**City of Gainesville**  
**Department of Doing**  
PO Box 490, Station 11  
Gainesville, FL 32627-0490  
306 NE 6<sup>th</sup> Avenue  
P: (352) 334-5022  
F: (352) 334-2648

**TO:** Development Review Board

**SUBJECT:** DB-17-072SPL George F Young Inc. agent for Integra Twenty Four LLC. Major Development Plan Review for the construction of a multi-family residential development. Zoned UMU-2 (Urban Mixed Use District 2 with 20-100du/acre). Located at the NW corner of SW 38th Terrace and SW 24th Avenue.

Figure 1: Layout of proposed development

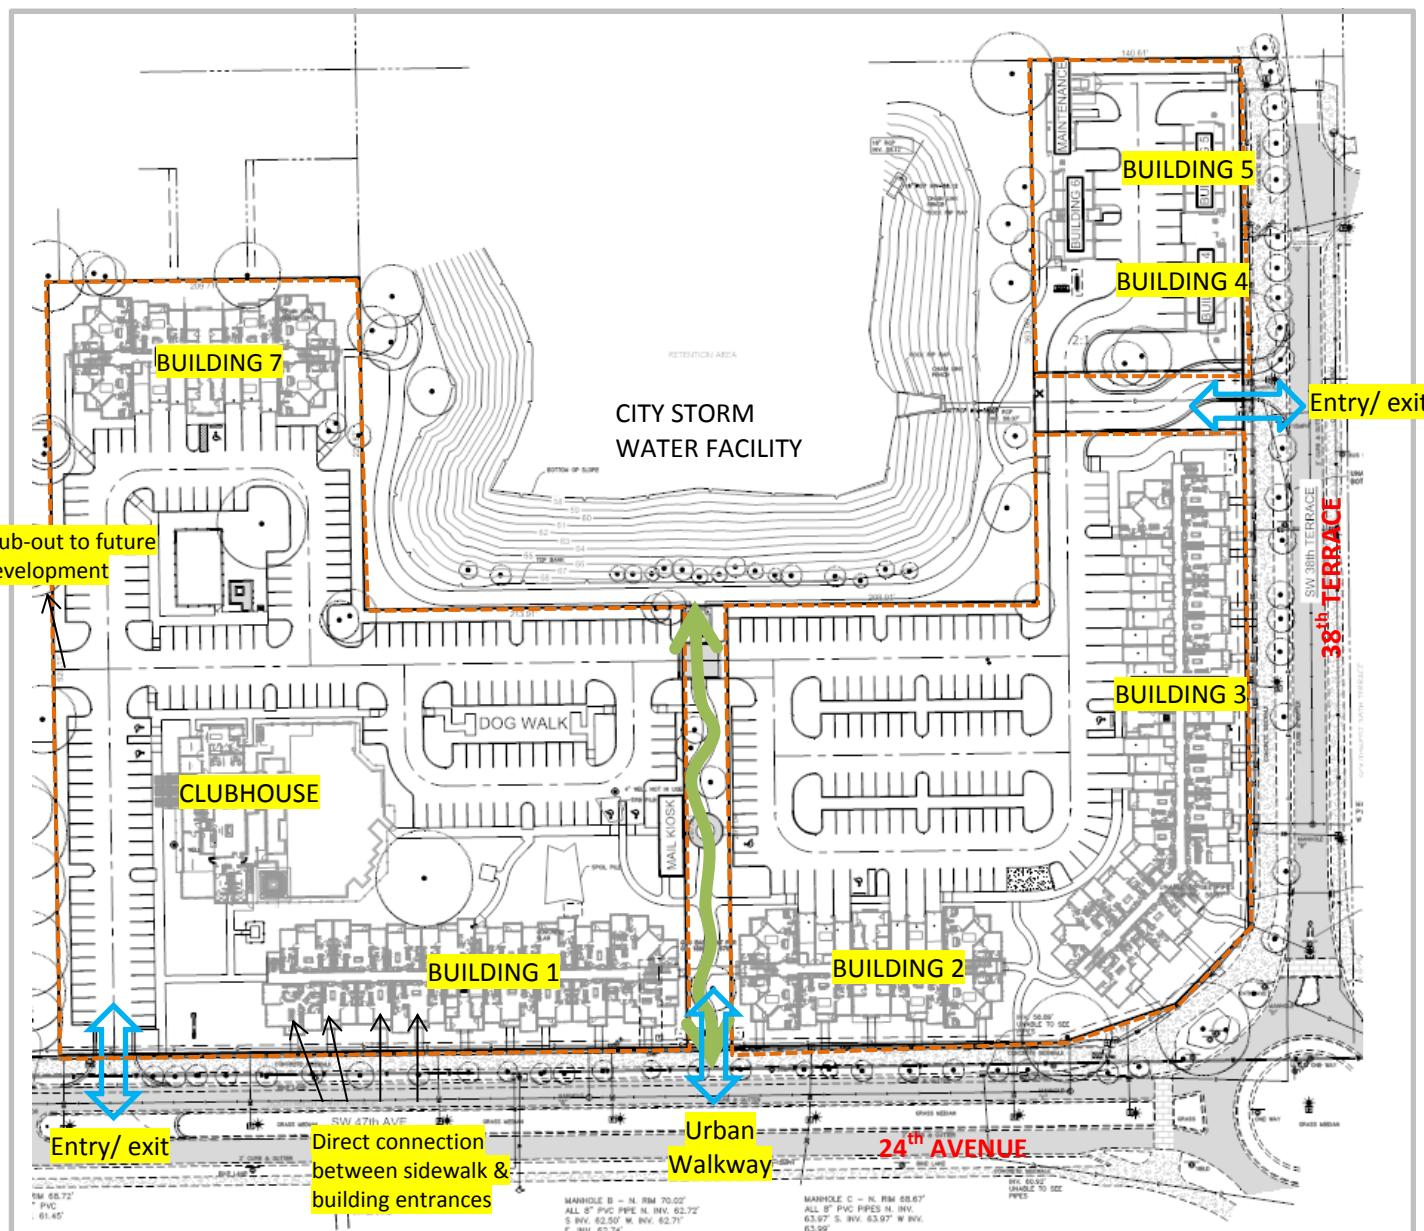
**Build-to-line:** The Urban Village district requires specific build-to-lines for specific street classifications (See Exhibit D). The build-to line is measured from back of curb and may be moved to the property line if it falls within the public right-of-way. The development complies with a build-to-line of 20 to 35 feet on SW 24<sup>th</sup> Avenue but does not meet the build-to-line requirement of 23 feet on SW 38<sup>th</sup> Terrace. The waiver is a result of the large width of the public right-of-way on SW 38<sup>th</sup> Terrace which puts the 23-foot build-to-line in the public right-of-way. The required build-to-line moves to the property line (30 feet from back of curb) per code. Additionally there was a need to

push the build-to-line further to accommodate utility separations. The applicant has therefore requested a waiver to move the build-to-line from 30 feet (on the property boundary) to 38 feet from back of curb, which staff supports.

**Lighting Design:** The photometric plan for the proposed development meets the requirements of the Outdoor Lighting section except for the mounting height of the luminaires on the parking lot. The Outdoor Lighting Code (Section 30-344(e)(4)) requires light poles on parking lots within 75 feet

of a residential development to have a luminaire mounting height of less than 15 feet to prevent glare and light trespass into nearby residences. The mounting height of luminaires on the proposed parking lot is 25 feet and exceeds the maximum height allowed under the Land Development Code.

***Condition 1:*** *Applicant shall maintain a maximum build-to-line of 38 feet from back-of-curb along SW 38<sup>th</sup> Terrace unless there is a need to accommodate utility separations or preserve significant trees. All other modifications to the build-to-line shall be subject to board approval.*

**Condition 3:** All lighting shall conform to the standards set in the Outdoor Lighting section of the Land Development Code.
